SUBJECT: Transmittal of Westinghouse Responses to US NRC Requests for Additional Information on the AP1000 Application for Design Certification

AP1000 DESIGN CERTIFICATION REVIEW

Response to Request For Additional Information

Figure 7.1-2

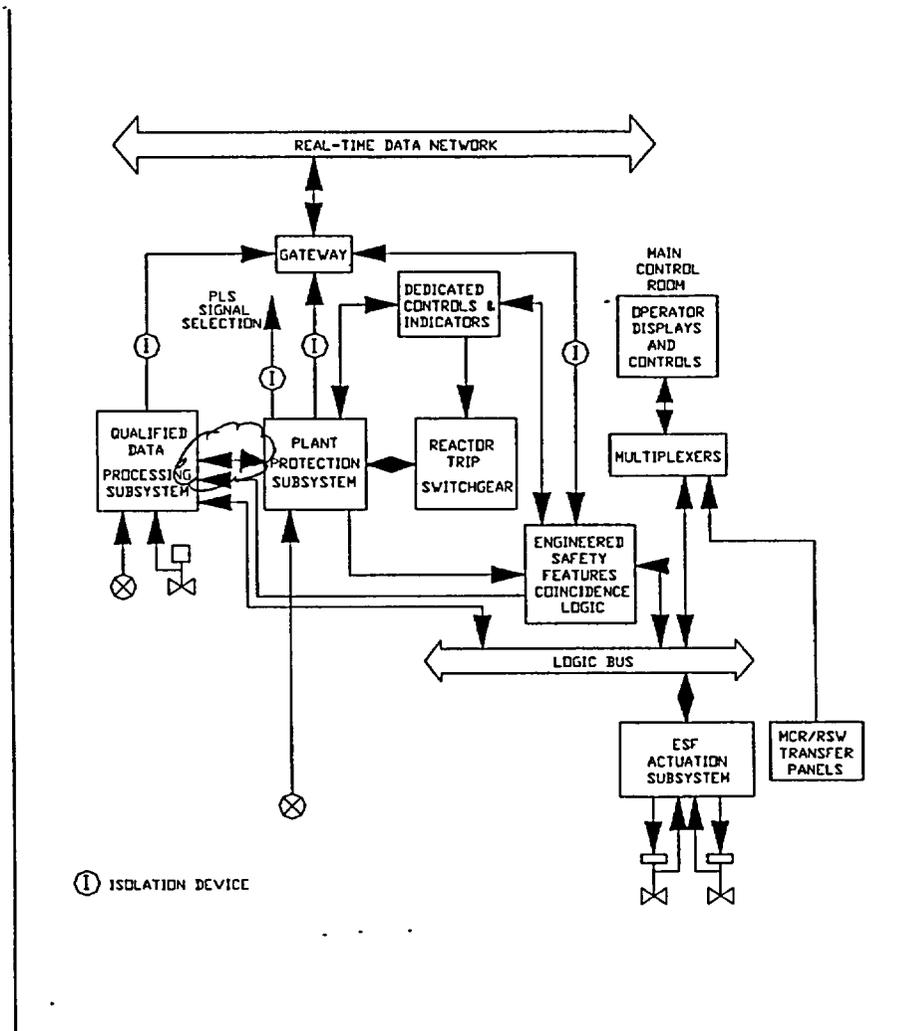
Describe the Qualified Data Processing Subsystems (QDPS) in more detail. DCD takes credit on the QDPS in the Defense-in-Depth and Diversity analysis. Describe the relationship between the QDPS and the RTS/ESFAS. Are the QDPS sharing sensors with the RTS or the ESFAS? (Figure 7.1-1 showing some sensors feed into plant protection subsystem directly while some sensors feed into QDPS subsystem). If the QDPS has separate sensors, do they have same qualification requirement as RTS/ESFAS ?

REVISION to DCD Figure 7.1-2

DCD Figures 7.1-1 and 7.1-2 will be revised to show two-way communication between the QDPS and the Plant Protection Subsystem. See attached mark-ups.

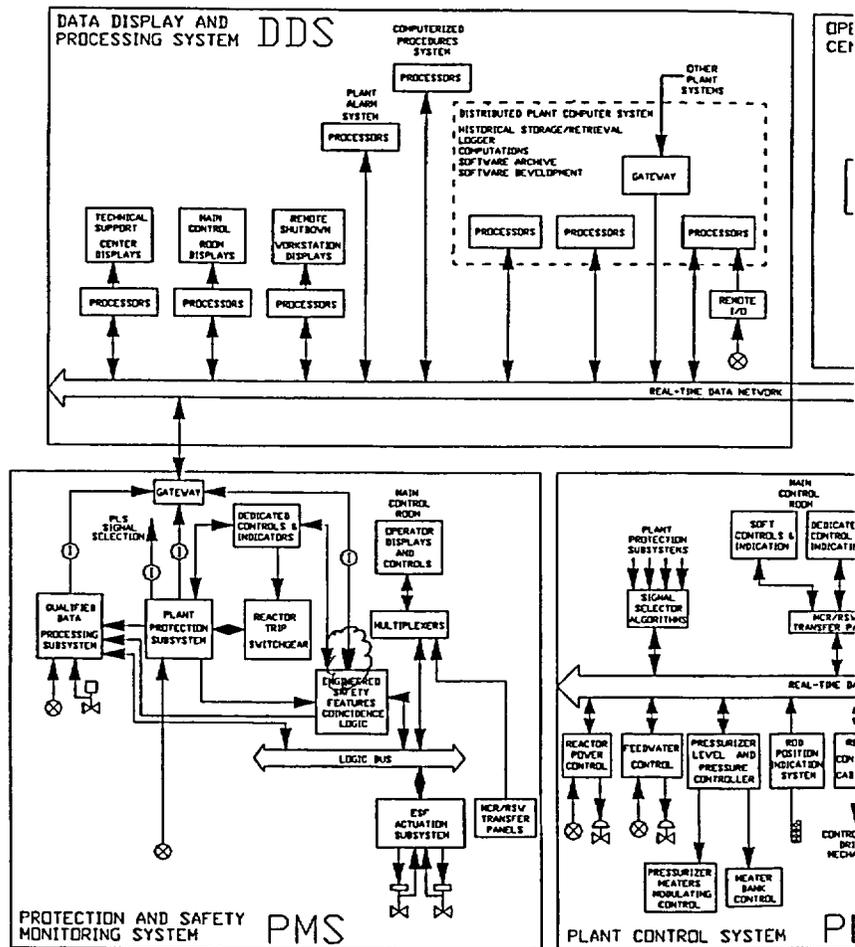
Note that there is an error in DCD Figure 7.1-1. The gateway needs to communicate to the Engineered Safety Features Coincidence Logic (as well as from the ESF Coincidence Logic) to accomplish the second function listed above. DCD Figure 7.1-2 (Revision 1) shows this link correctly.

Revise DCD Figure 7.1-1 as shown.

**Figure 440.43-1 AP1000 Multiple (5 Tubes) SGTR with PORV Failure
Tube Rupture Break Flow**

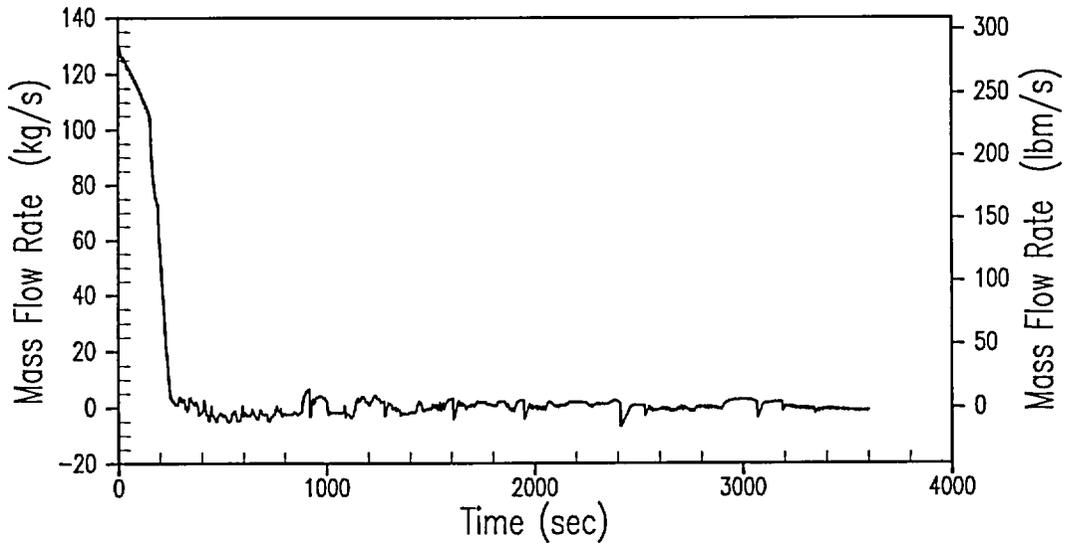
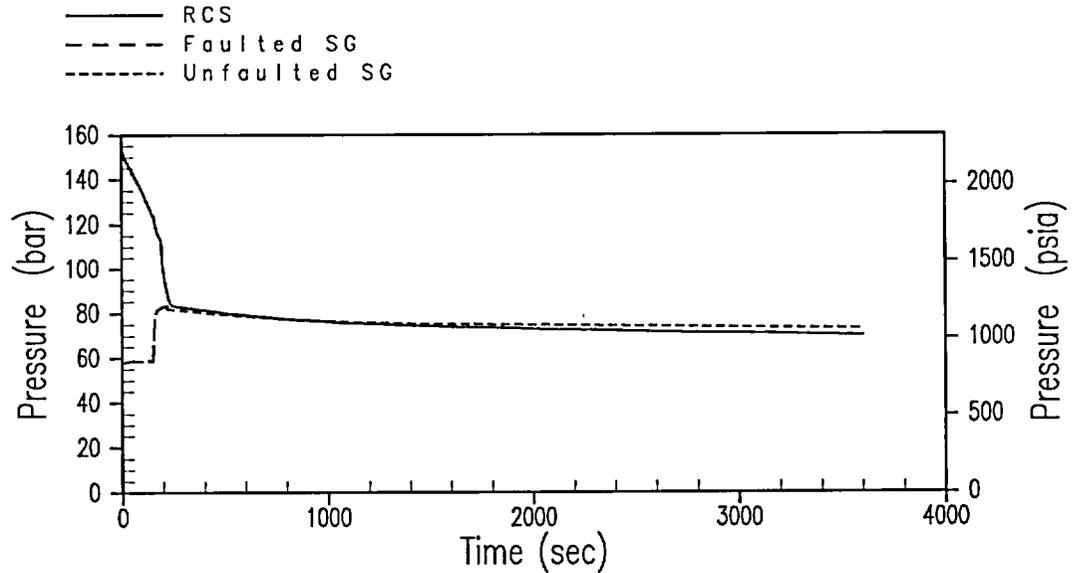
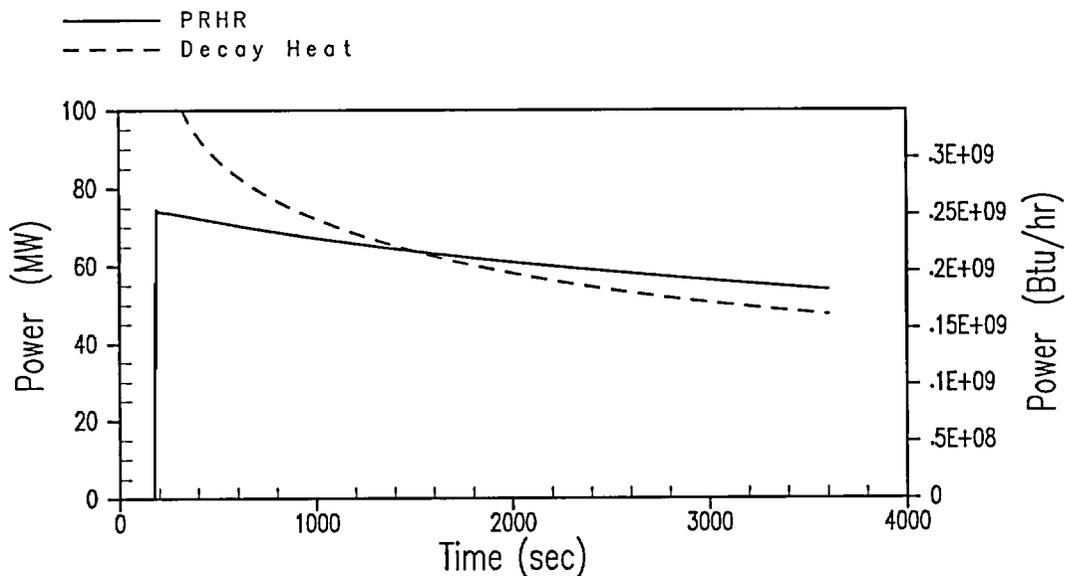
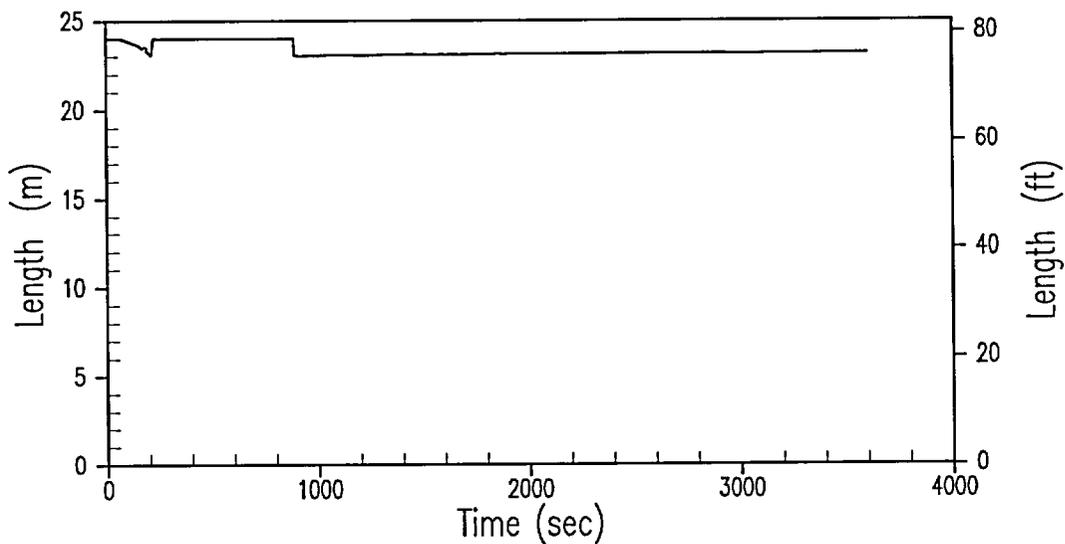
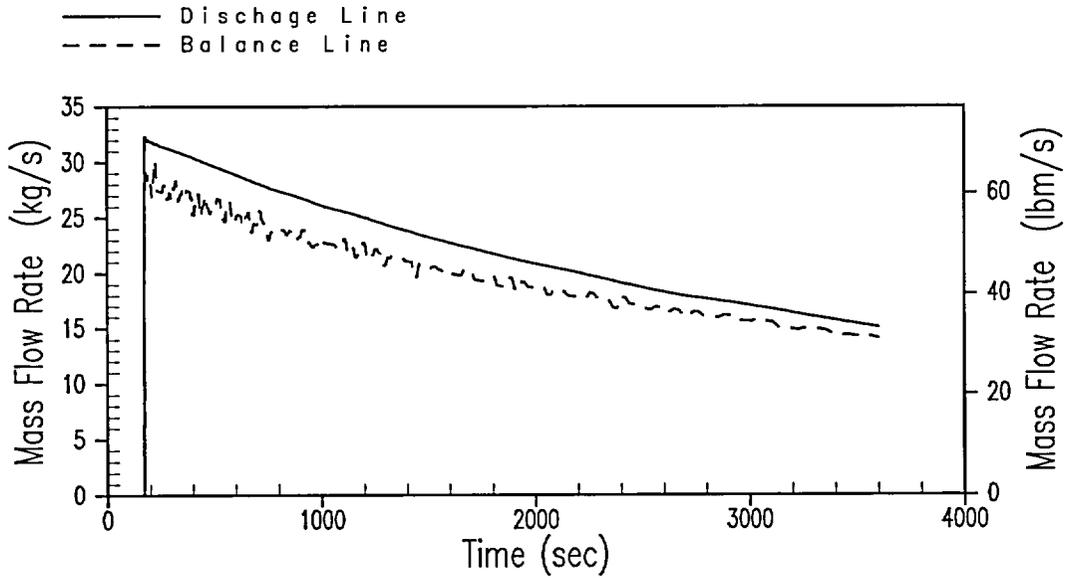
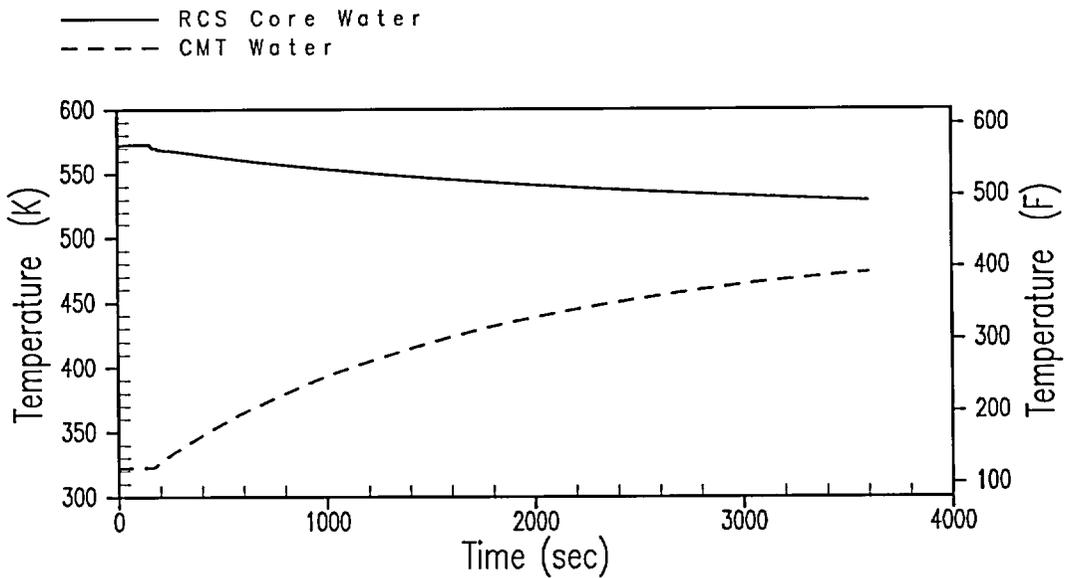
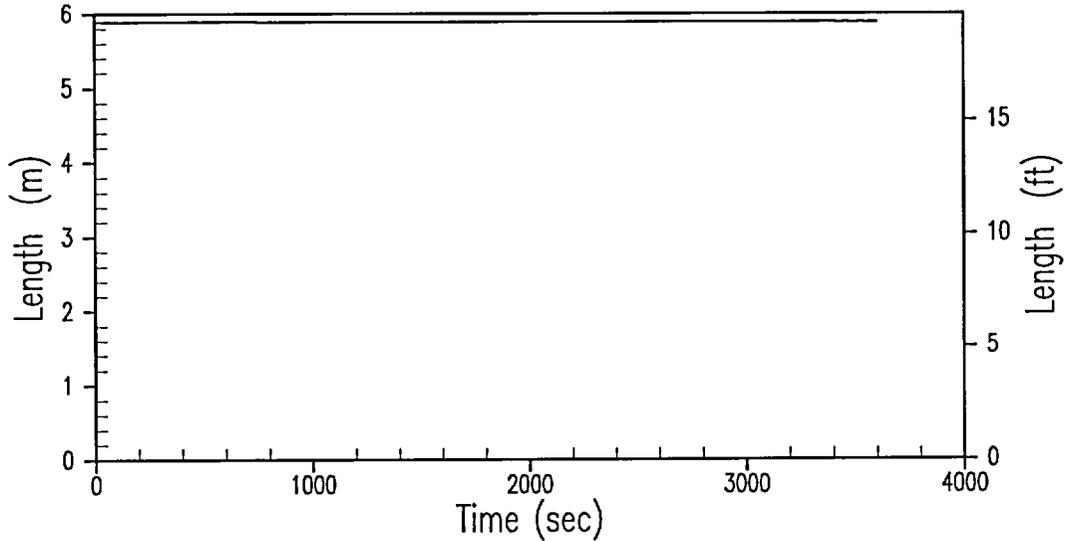
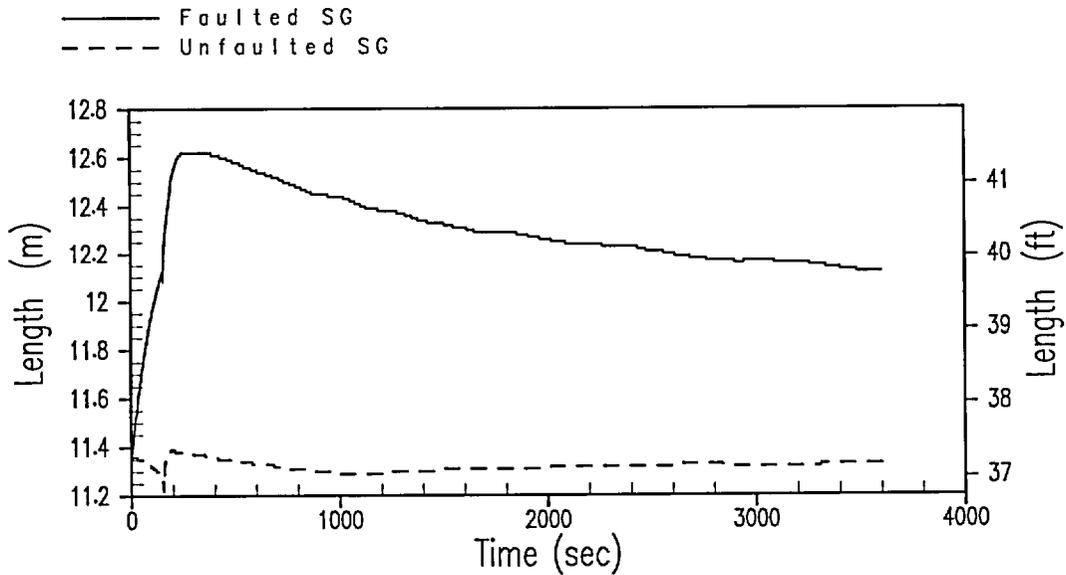
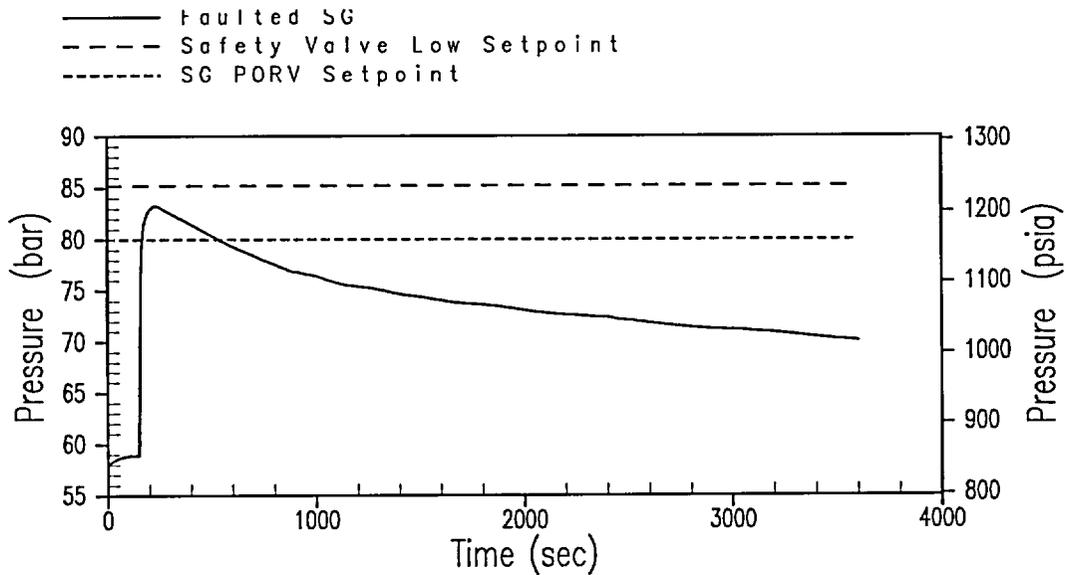
- A. Discuss the AP1000 design features that mitigate or prevent SGSV challenges during an event of rupture of multiple steam generator tubes.
- B. Provide an analysis of multiple-tube rupture events to address the concern of containment bypass leakage resulting from a potential failure of the SGSV to reclose.

The MAAP4 results are presented in Figure 440.43-1 through 440.43-9. The results show that the faulted SG does not overflow and the safety valves do not open. Therefore, bypass does not occur.
